NEW MEXICO ENERGY, MINERALS  
& NATURAL RESOURCES DEPARTMENT

*Re: Administrative application for waterflood expansion pursuant to Division General Rules 701.G(6) and 701.C for the Lusk West (Delaware) Unit Waterflood Project in Sections 20, 21, and 29, Township 19 South, Range 32 East, NMPM, designated and Undesignated West Lusk-Delaware Pool, Lusk West (Delaware) Unit, Lea County, New Mexico.*

CASE NO. 11704  
ORDER NO. R-10863

### **SUMMARY OF WELLS TO BE REVIEWED IN ACCORDANCE WITH ORDER NO. R-10863**

## Plains Unit Federal #4-Y

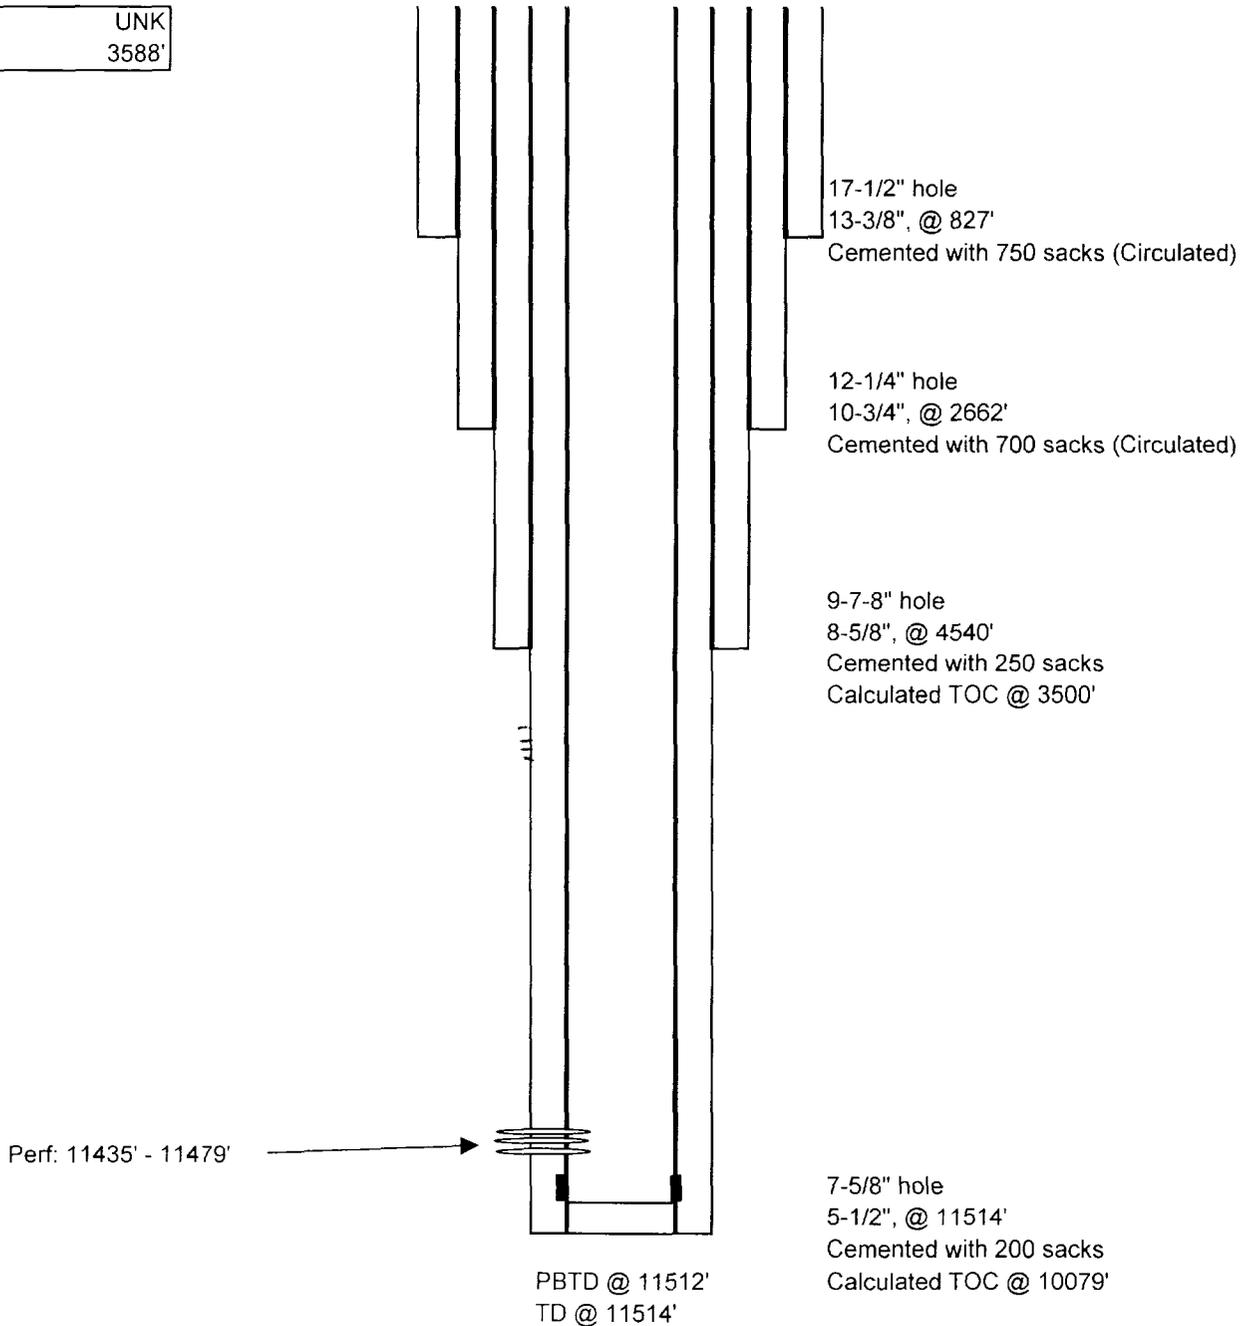
**Well Name:** Plains Unit Federal #4-Y  
Current Status: Strawn Producer (Perforated 11435' - 11479')  
Open Interval: 4540' - 10079'  
Waterflood Interval: 6478' - 6492'  
Porosity: 3% to 5% (15% Minimum Required to produce fluid)  
Thickness: 14 Feet  
Zone Quality: Interbedded Shale, Silt, and Carbonate (Tight), Non-Reservoir Quality

**Upon this review, Mr. Williams concluded that no additional work was required by PNR concerning these eight wells in order to prevent the migration of fluid from the proposed injection zone to the eight wellbores in question.**

## Shackelford Oil Plains Unit Fed. #6

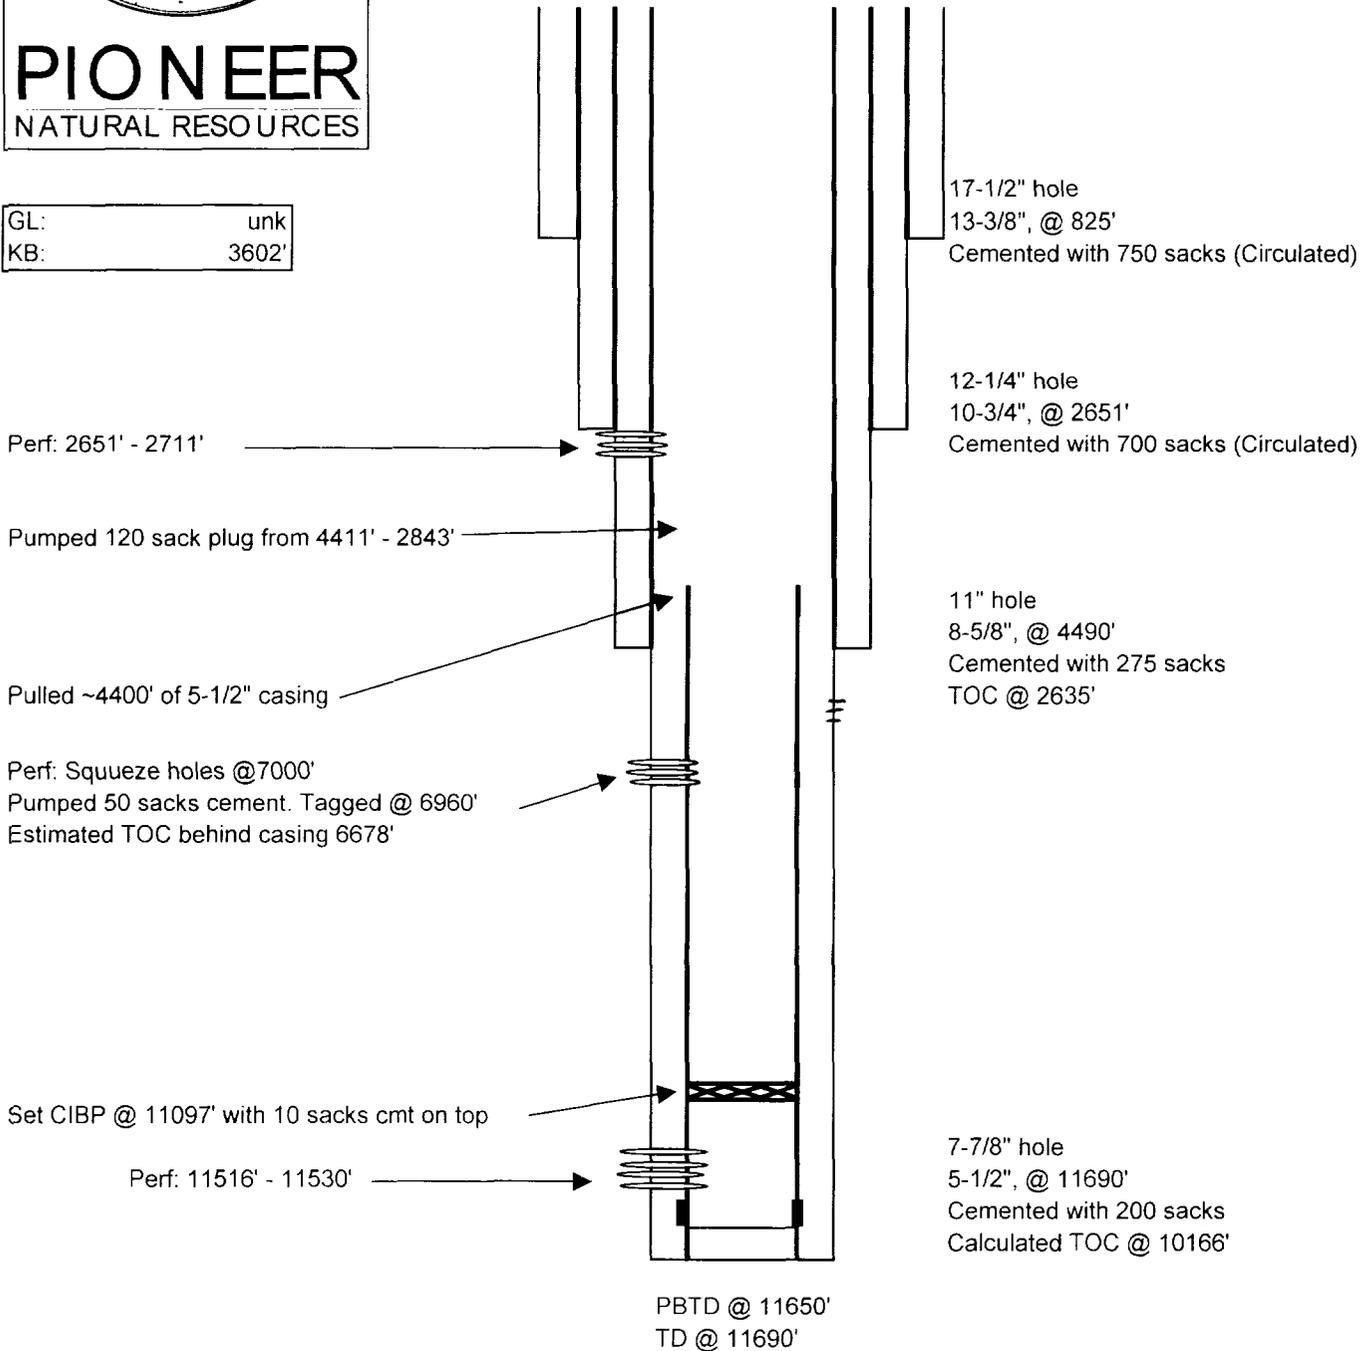
**Well Name:** Shackelford Oil Plains Unit Federal #6  
Current Status: Yates Producer (Perforated 2651' - 2711')  
Open Interval: 4490' - 6678'  
Waterflood Interval: 6464' - 6492'  
Porosity: 16% to 18%  
Thickness: 28 Feet  
Zone Quality: Very Good

## Lusk Deep Unit "A" #3

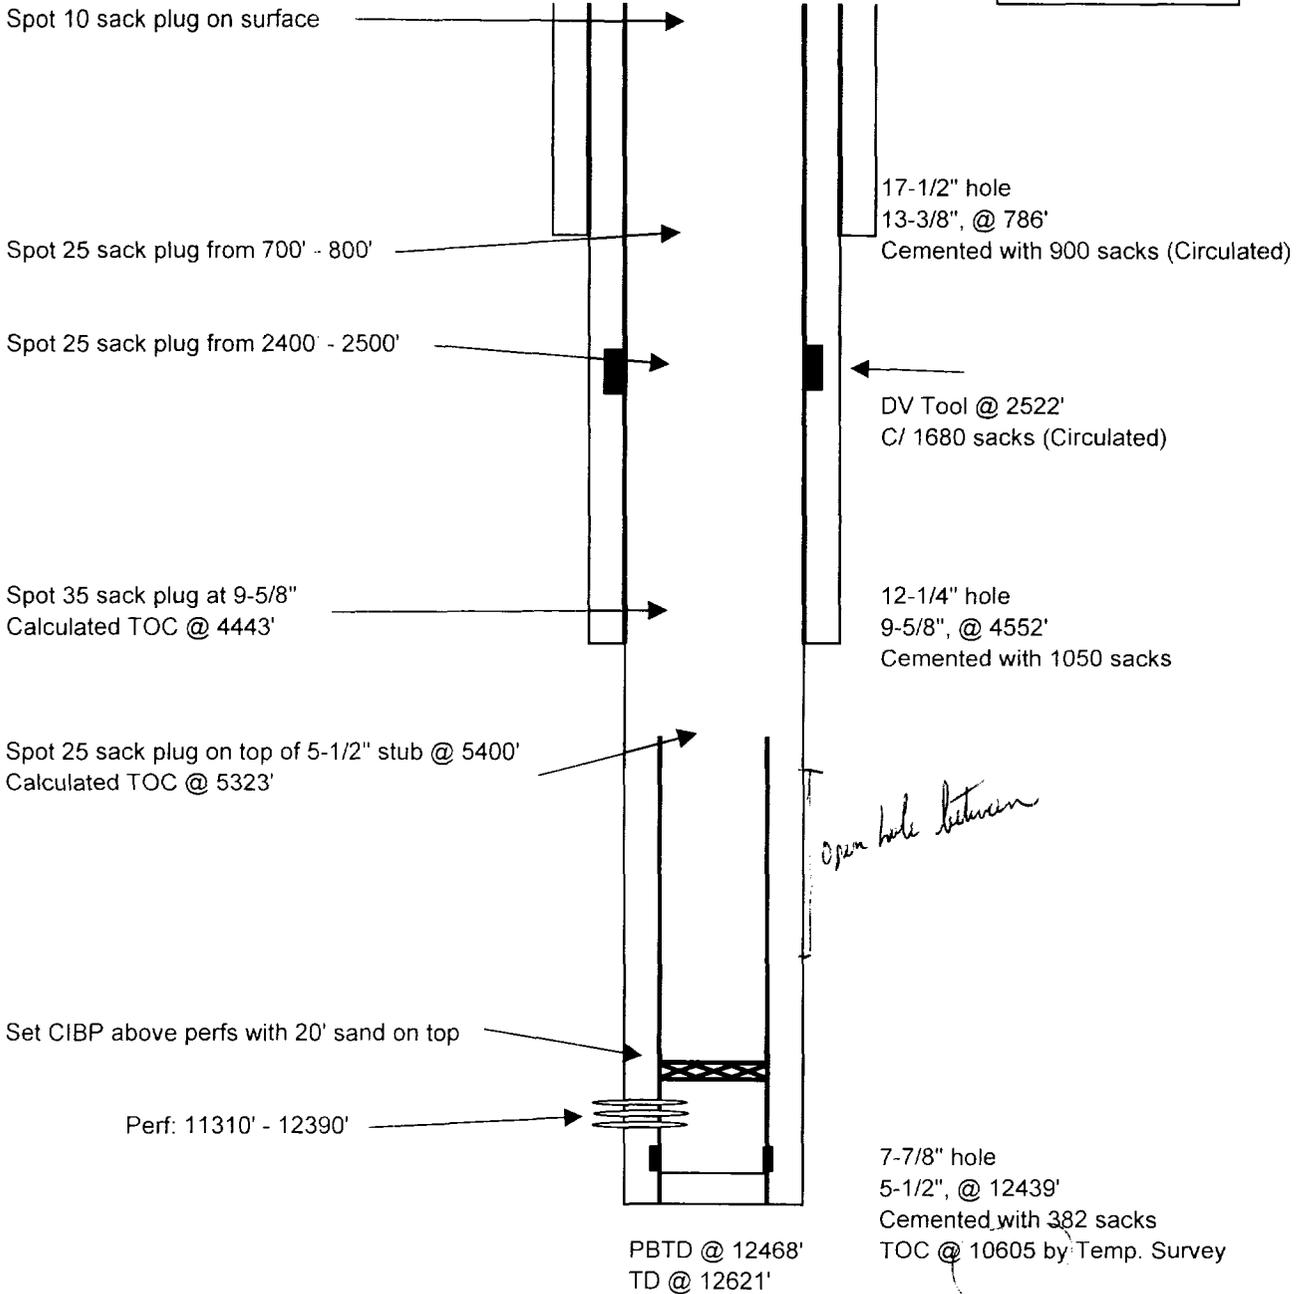
**Well Name:** Lusk Deep Unit "A" #3  
Current Status: Plugged and Abandoned  
Open Interval: 5400' - 11000'  
Waterflood Interval: 6400' - 6412'  
Porosity: 10% to 12% (15% Minimum Required to produce fluid)  
Thickness: 12 Feet  
Zone Quality: Interbedded Shale, Silt, and Carbonate (Tight), Non-Reservoir Quality

## Lusk Deep Unit "A" #7

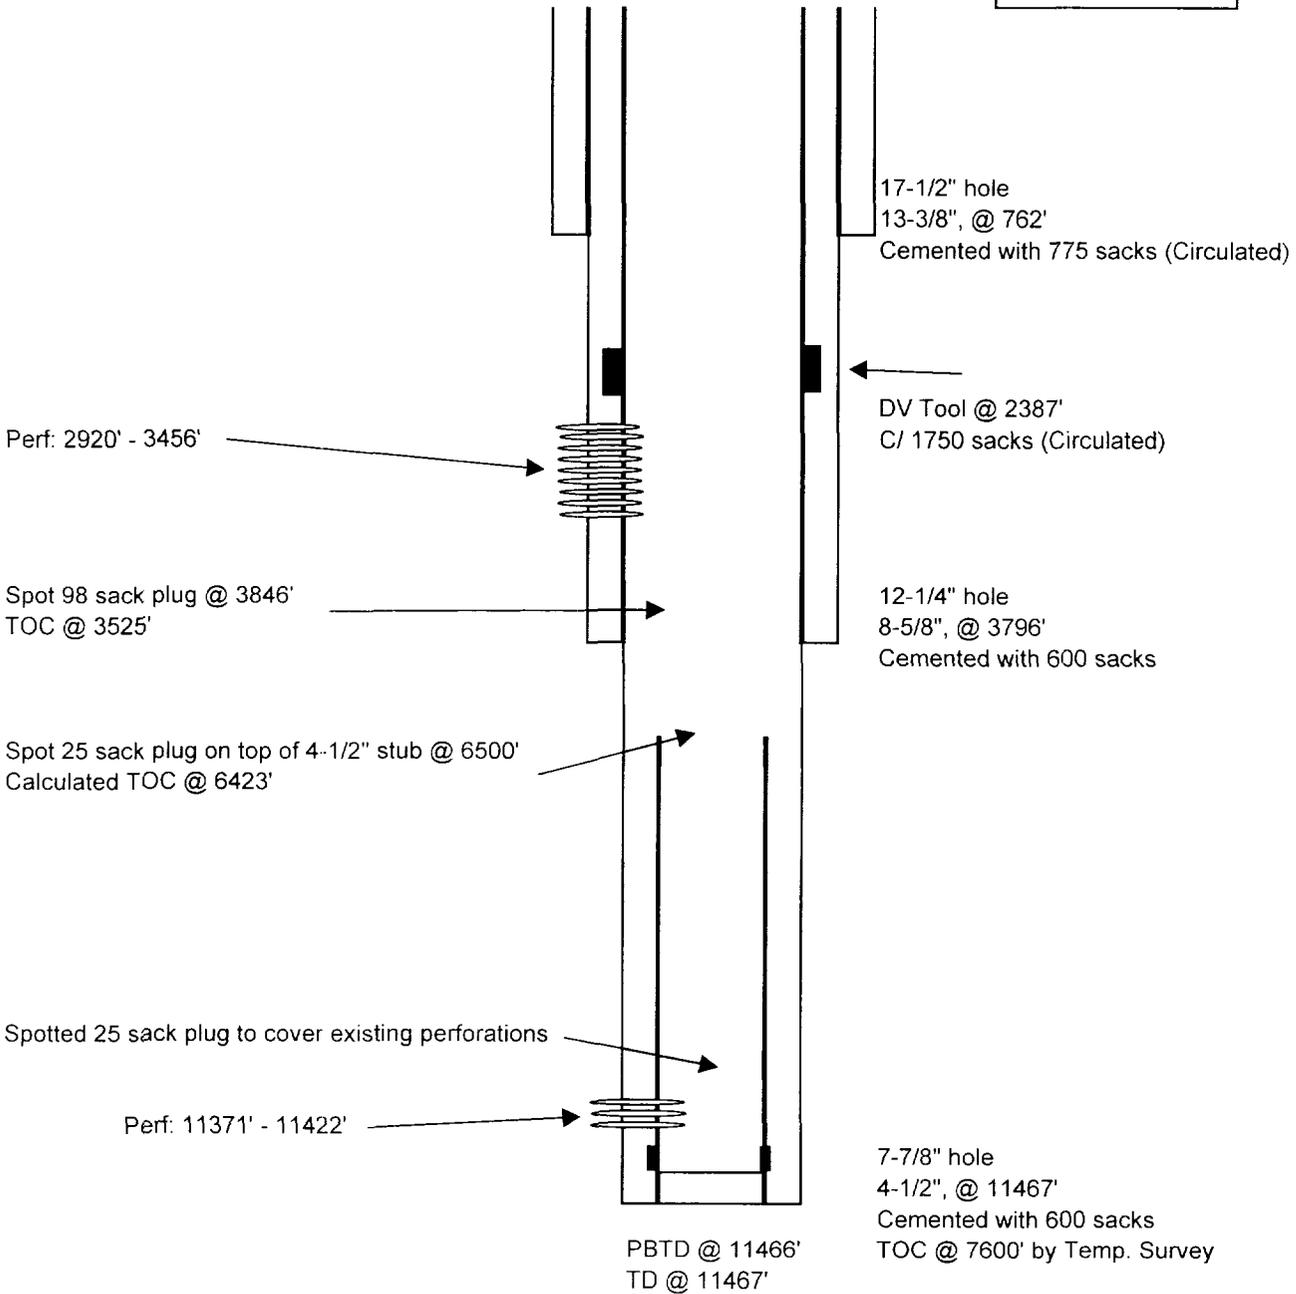
- (1) Information on the well in Unit "L" of said Section 20 indicated on the map as the Lusk Deep Unit "A" Well No. 7;
- (2) Additional data and/or a detailed explanation showing that injected water into the proposed Lusk West Delaware Unit Well No. 903 will remain confined in the narrow injection interval. The well in Unit "A" of Section 30, Township 19 South, Range 32 East, NMPM, Lea County, New Mexico in within the ½ mile area of review ("AOR") of the proposed Lusk West Delaware Unit Well No. 903 and the information provided me indicates that there is no cement protection behind pipe within the proposed injection interval;
- (3) Since the information provided by Parker & Parsley

**Well Name:** Lusk Deep Unit "A" #7  
Current Status: Seven Rivers Water Supply Well (Perforated 2920' - 3456')  
Open Interval: 3846' - 6423'  
Waterflood Interval: 6410' - 6417'  
Porosity: 3% to 5% (15% Minimum Required to produce fluid)  
Thickness: 7 Feet  
Zone Quality: Interbedded Shale, Silt, and Carbonate (Tight), Non-Reservoir Quality

## Plains Unit Federal #4

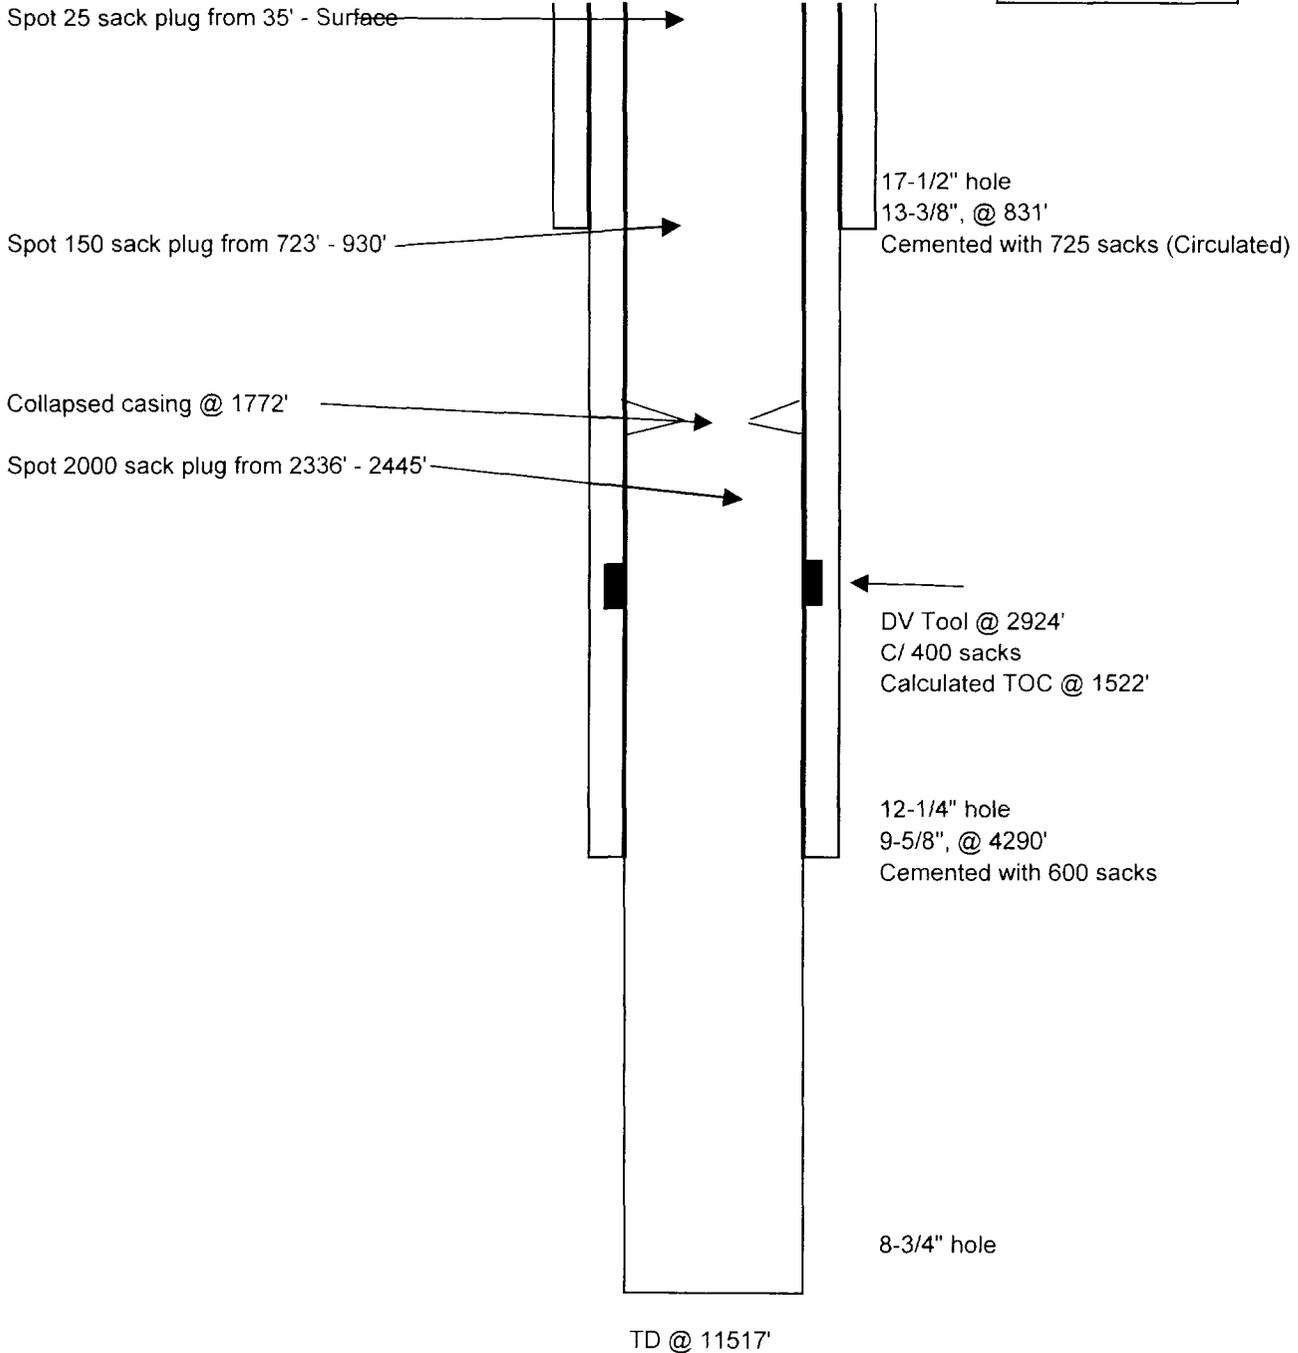
**Well Name:** Plains Unit Federal #4  
Current Status: Junked and Abandoned  
Open Interval: 4290' - 11,517'  
Waterflood Interval: Estimated 6500' - 6517' (No Logs Available)  
Porosity: Fair to Good  
Thickness: ~17 Feet  
Zone Quality: Producable

## Southern California Federal #2

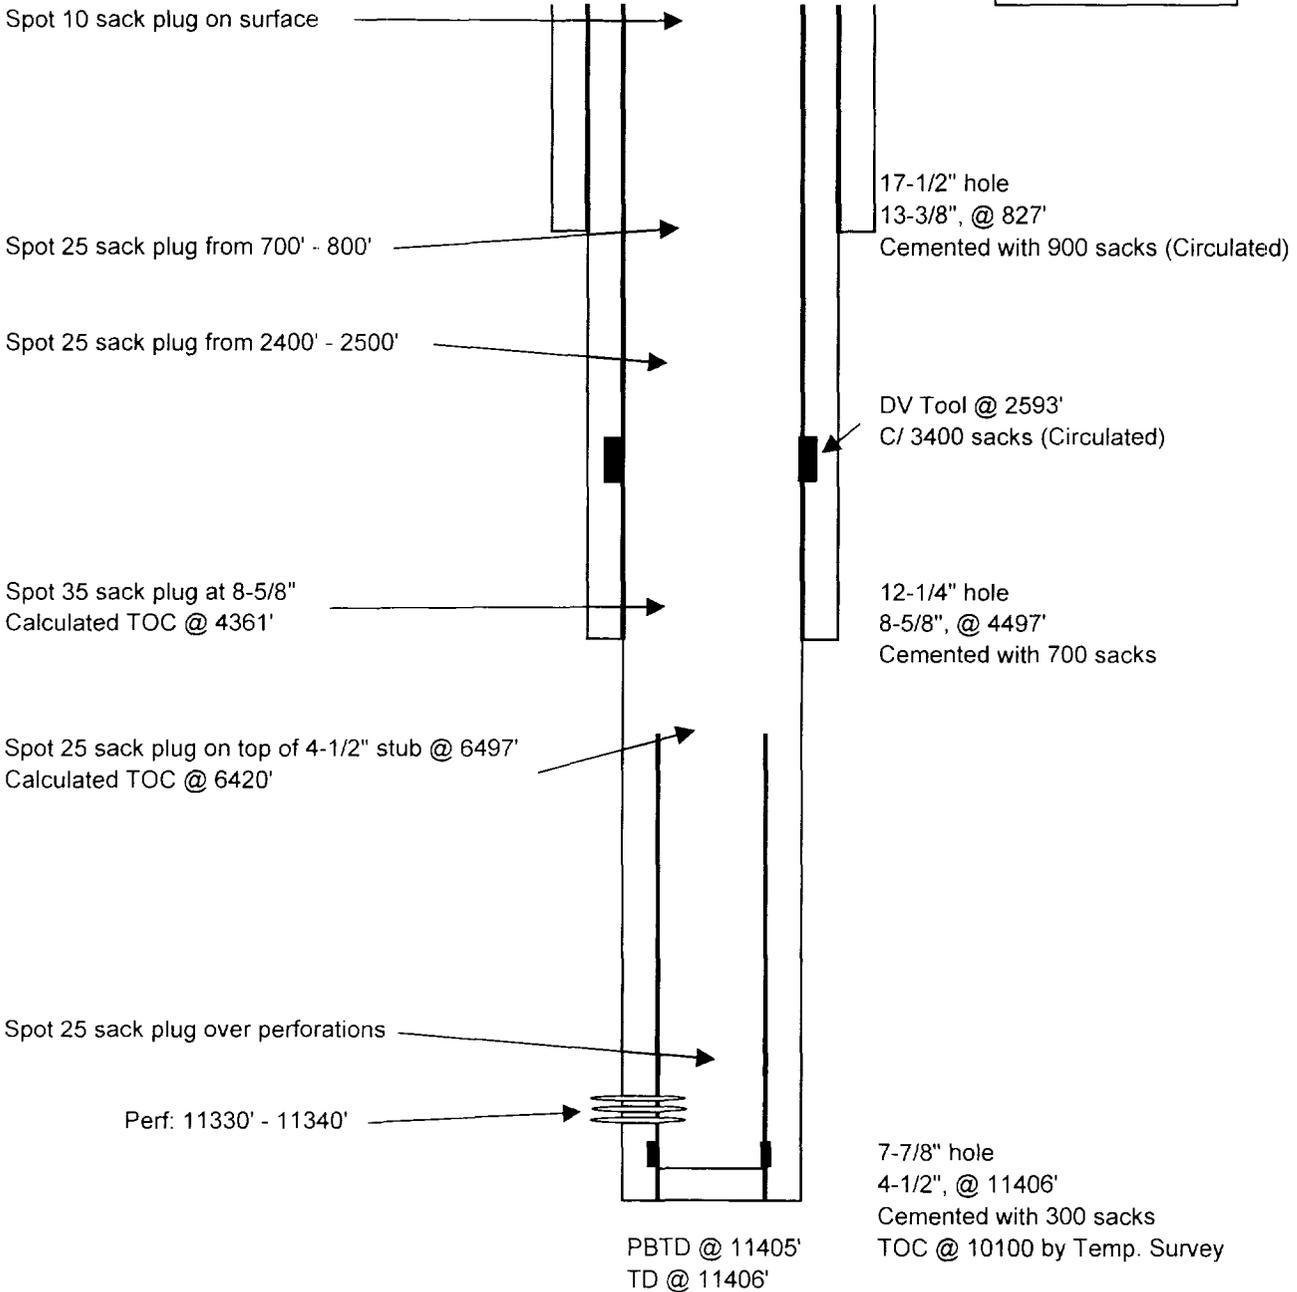
**Well Name:** Southern California Federal #2  
Current Status: Plugged and Abandoned  
Open Interval: 4497' - 6420'  
Waterflood Interval: 6408' - 6412'  
Porosity: 4% to 6% (15% Minimum Required to produce fluid)  
Thickness: 4 Feet  
Zone Quality: Interbedded Shale, Silt, and Carbonate (Tight), Non-Reservoir Quality
